ADDENDUM NO. 1

April 1, 2022

**PROJECT: Jerome Elementary School
Jerome School District
Jerome, Idaho**

11 TECTUM SOUND PANEL DETAIL
3/4" = 1'-0"

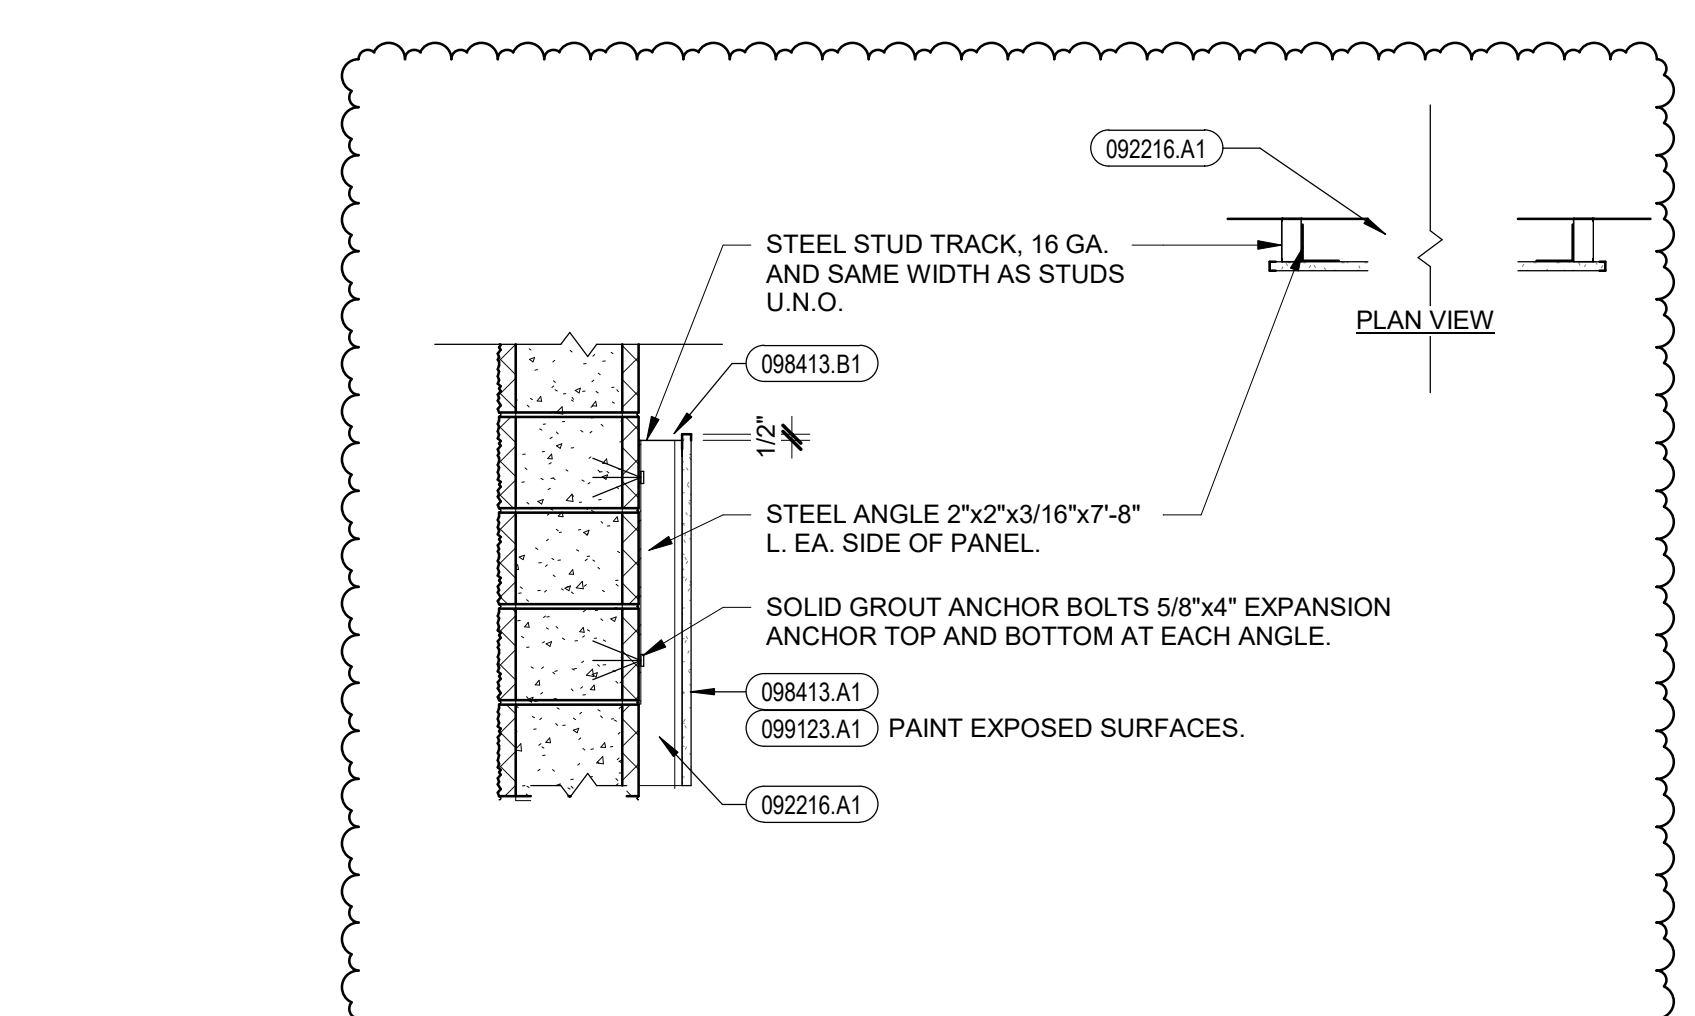
1. Provide new attachment detail 11/A8.6 for tectum sound panel per revised sheet A8.6, attached.

S1.05
 FOOTING AND FOUNDATION
 PLAN - AREA E

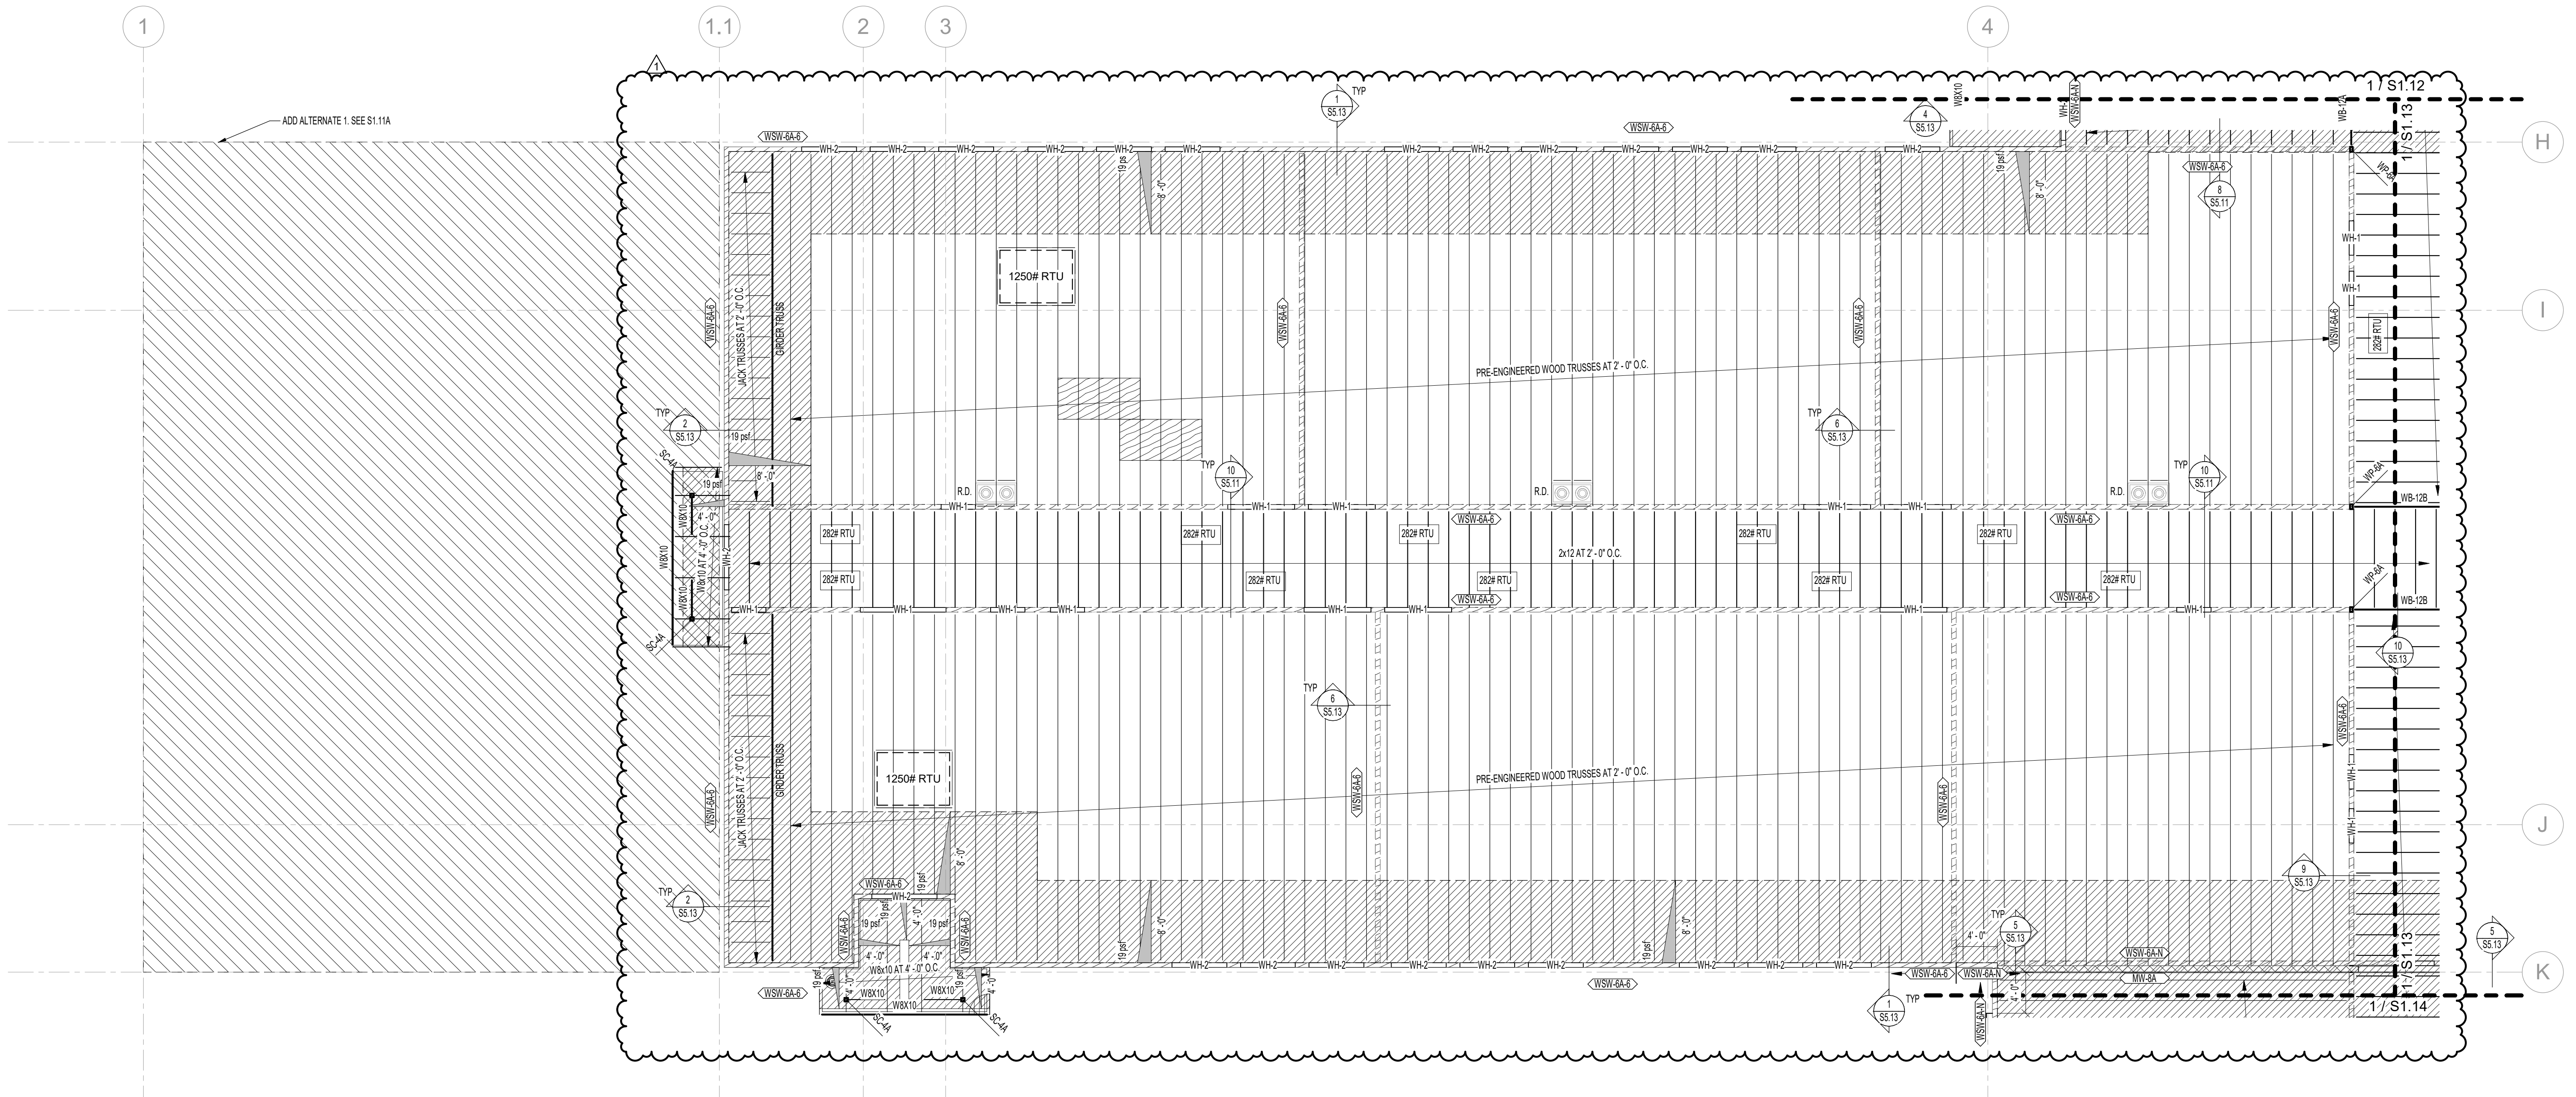
- S1.05
 - Revised holdowns on grids 7 and 11
- S1.11 through S1.16
 - Revised snow loading
- S5.12
 - Revised detail 13
- S5.13
 - Revised detail 6
- S6.02
 - Revised the masonry wall and masonry pier schedules
